The title of the invention is not descriptive. A new title is required that is clearly indicative of the invention to which the claims are directed.

The following title is suggested: "Infrared Radiator With Carbon Fiber Heating Element Centered By Spacers."

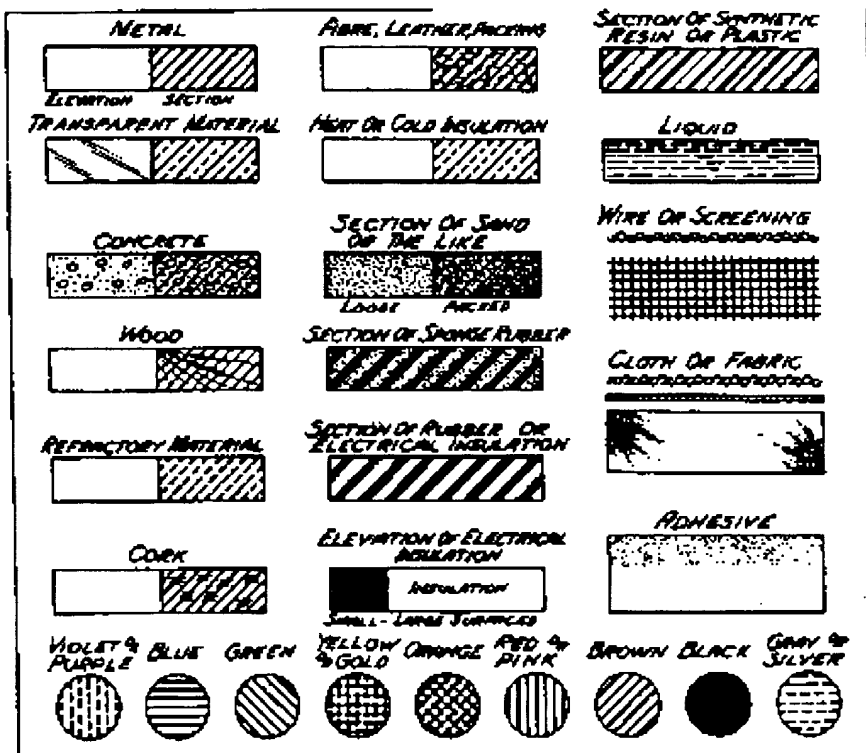
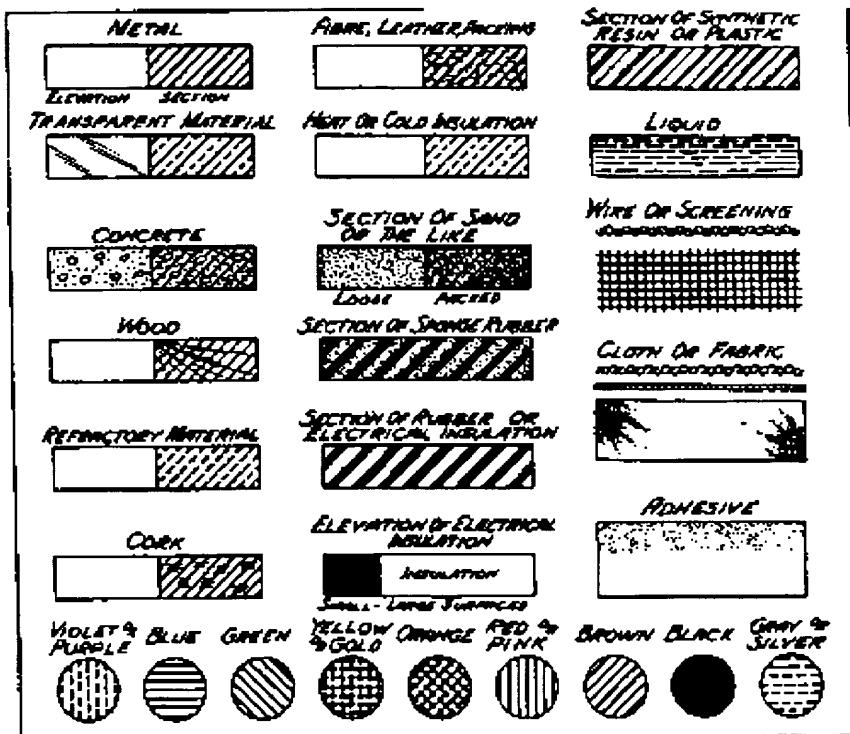
Fig. 1-8, and 15: Proper cross-sectional hatching is required to properly denote metallic, transparent, and insulative materials in accordance with MPEP 608.02 (see the drawing below for proper hatching examples). Moreover, all structures denoted by a darkened single line must be given a thickness and appropriately hatched in cross section for clarity.
